SUBJECT: Contract No. DE-AC24-97OH20044
**ACTION MEMORANDUM – CONTINGENT REMOVAL ACTION FOR
CONTAMINATED SOIL – PUBLIC REVIEW DRAFT**

RESPONSES TO COMMENTS FROM
OHIO EPA AND ODH/BRP ON THE
ACTION MEMORANDUM EE/CA
CONTINGENT REMOVAL ACTION FOR CONTAMINATED SOIL
DRAFT REVISION 0
JULY 2001

**ACTION MEMORANDUM
ENGINEERING EVALUATION/COST ANALYSIS**

**MOUND PLANT
MIAMISBURG, OHIO**

Figure 2.1 Location of Identified PRSs for this Contingent Removal Action
(PRS 153, 266, 273, 276, 412, and 421 - Outlined in Red)

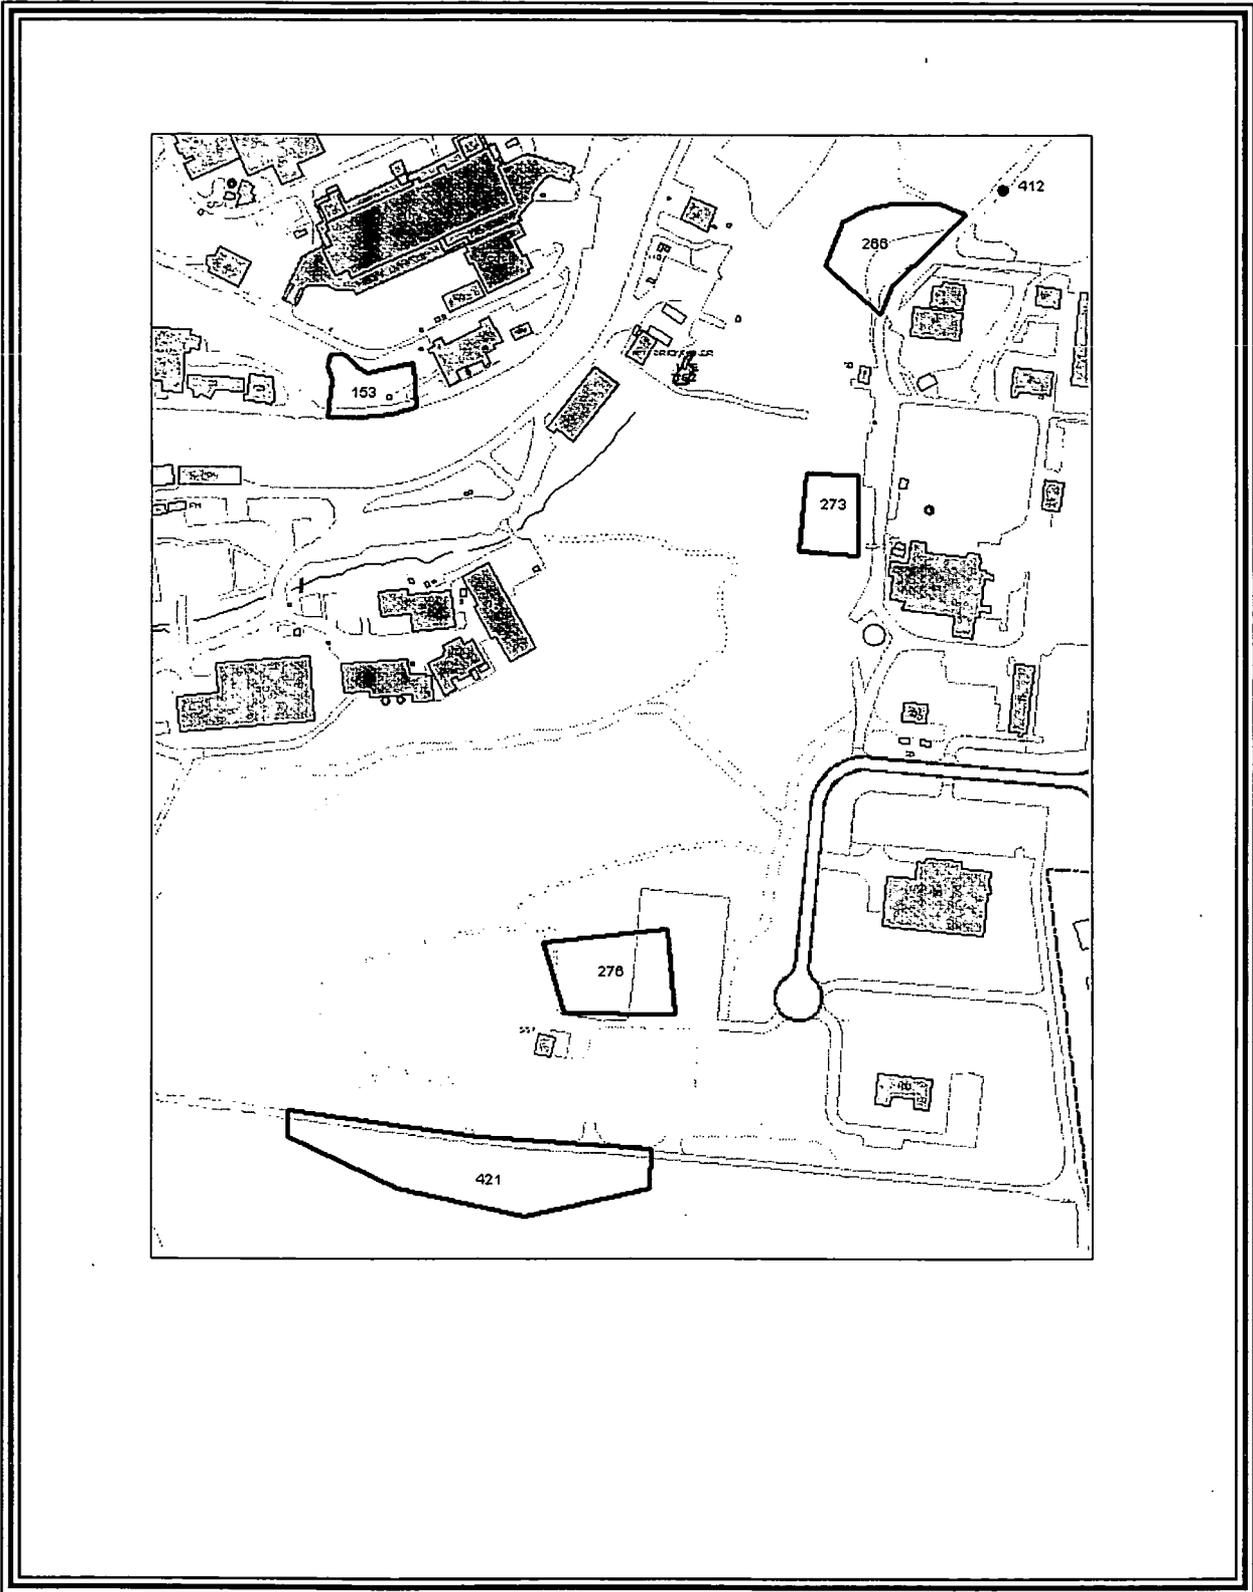
5. Figure 21

Page 3 of 21

Eliminate all PRSs except PRS 276 and PRS 421. Also note that the boundaries of PRS 75 extend west under the current soil loading area. This PRS was deferred because the contaminated soil loading area will continue to be utilized.

By continuing discussion, US EPA, OEPA, DOE, and BWXTO reached agreement without restricting the applicability to PRS 276 and 421. PRS 75 was removed.
